The follow drawing, see attached your exhibit E
and F of report.

③ and ④ mark indentify the spectral component as your E-mail

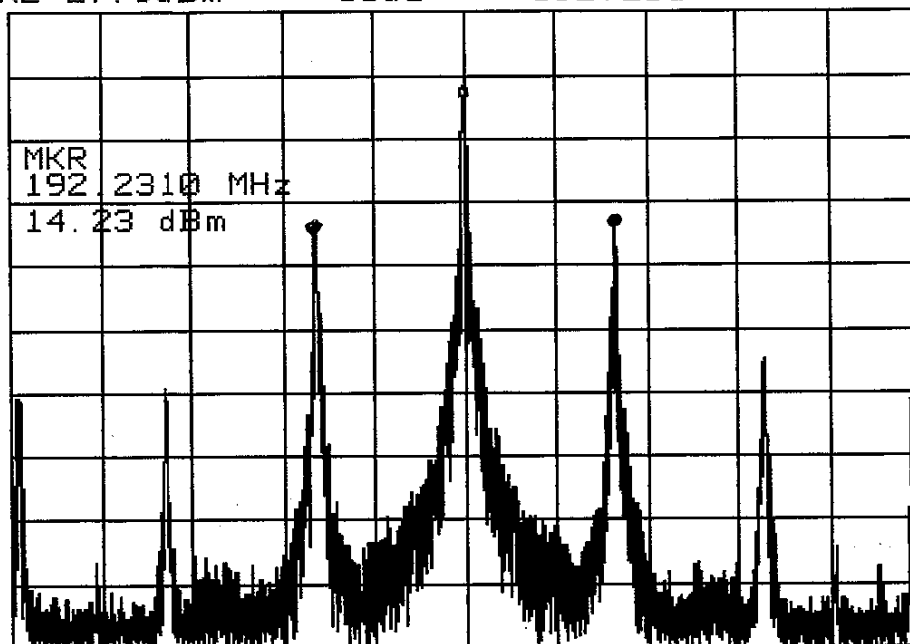
This chart
included pilo
with 37.768kHz
tone frequency
when unmodulat
